### **Addendum 40: Regulation No. 41**

#### **Revision 1 - Amendment 1**

03 series of amendments - Date of entry into force: 5 February 2000

**UNIFORM PROVISIONS CONCERNING THE APPROVAL OF MOTORCYCLES  
WITH REGARD TO NOISE**

Figure 2  
Test for stationary vehicle

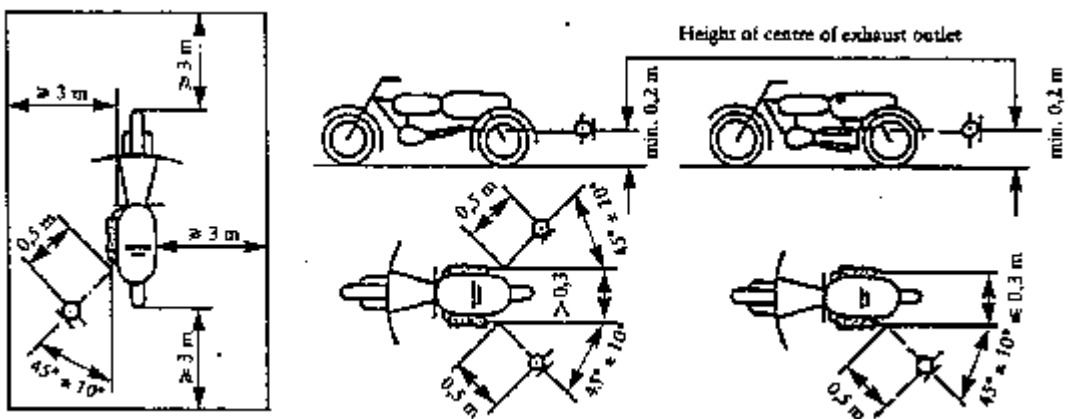
2.3.2. Test site (See appendix - figure 2)

2.4.2. Positioning of the microphone (See appendix - figure 2)

The microphone shall be positioned level with the exhaust outlet or 0.2 m above the surface of the track, whichever is the highest. The microphone diaphragm shall face towards the exhaust outlet at a distance of 0.5 m from it. The axis of maximum sensitivity of the microphone shall be parallel to the surface of the track at an angle of  $45^{\circ} \pm 10'$  to the vertical plane of the direction of the exhaust emissions.

**Figure 1:** Minimum requirements for test surface area. The shaded part is called "Test Area".

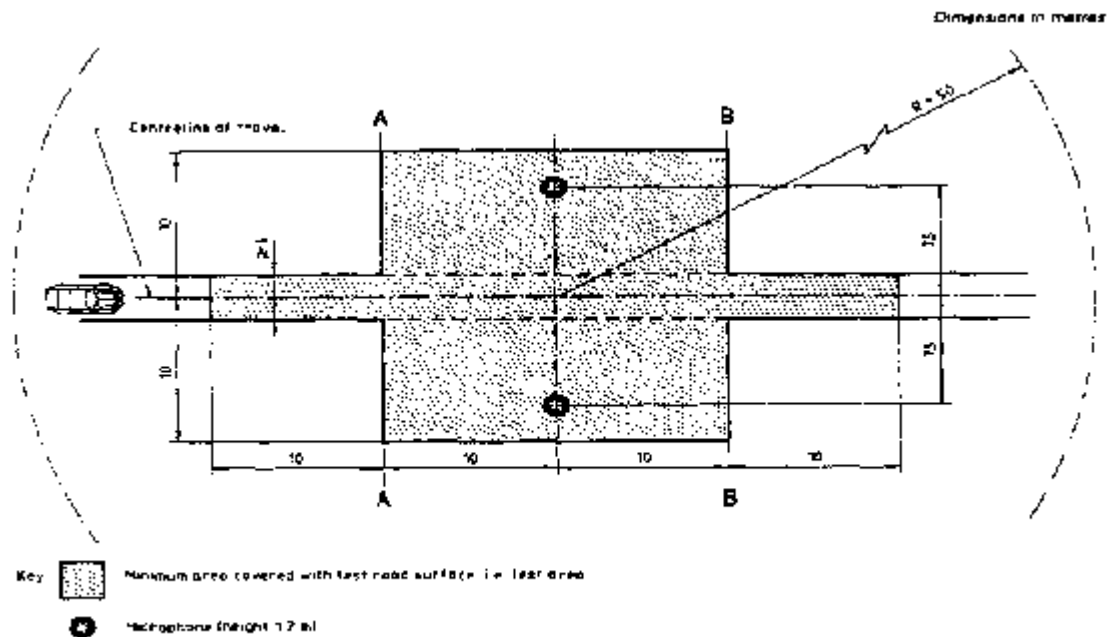
Insert the following new Annex 4:

When designing the test track layout it is important to ensure that, as a minimum requirement, the area traversed by the vehicles running through the test strip is covered with the specified test material with suitable margins for safe and practical driving. This will require that the width of the track is at least 3 m and the length of the track extends beyond lines AA and BB by at least 10 m at either end. Figure 1 shows a plan of a suitable test site and indicates the minimum area which shall be machine laid and machine compacted with the specified test surface material. According to annex 3, paragraph 3.1.1.1., measurements have to be made on each side of the vehicle. This can be made either by measuring with two microphone locations (one on each side of the track) and driving in one direction, or measuring with a microphone only on one side of the track but driving the vehicle in two directions. If the former method is used, then there are no surface requirements on that side of the track where there is no microphone.

Figure 2: Grading curve of the aggregate in the asphaltic mix with tolerances

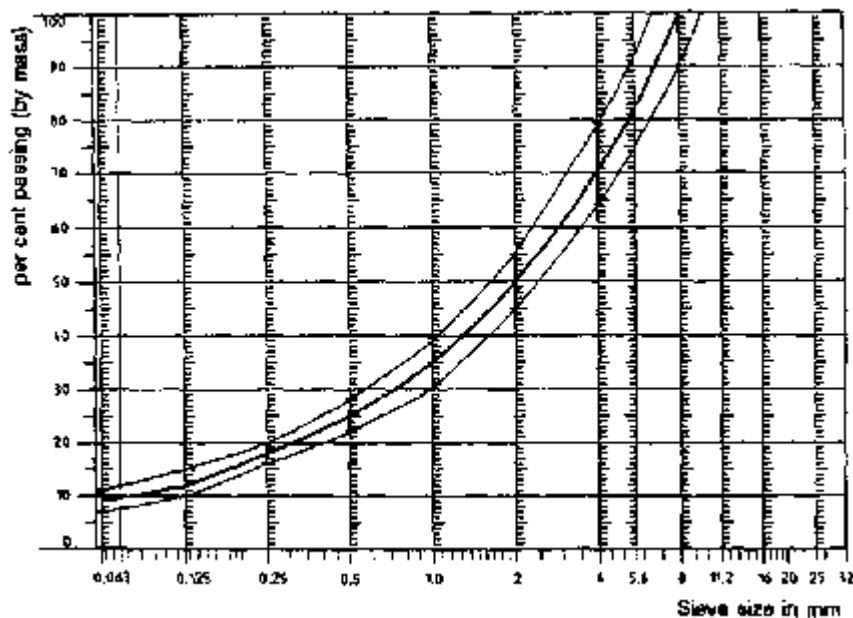
As a guide to the surface constructor, an aggregate grading curve which will give desired characteristics is shown in Figure 2. In addition, Table 1 gives some guidelines in order to obtain the desired texture and durability. The grading curve fits the following formula:

$$P (\% \text{ passing}) = 100 \cdot (d/d_{\max})^{1/2}$$

where:  $d$  = square mesh sieve size, in mm  
 $d_{max}$  = 8 mm for the mean curve  
 $d_{max}$  = 10 mm for the lower tolerance curve  
 $d_{max}$  = 6.3 mm for the upper tolerance curve
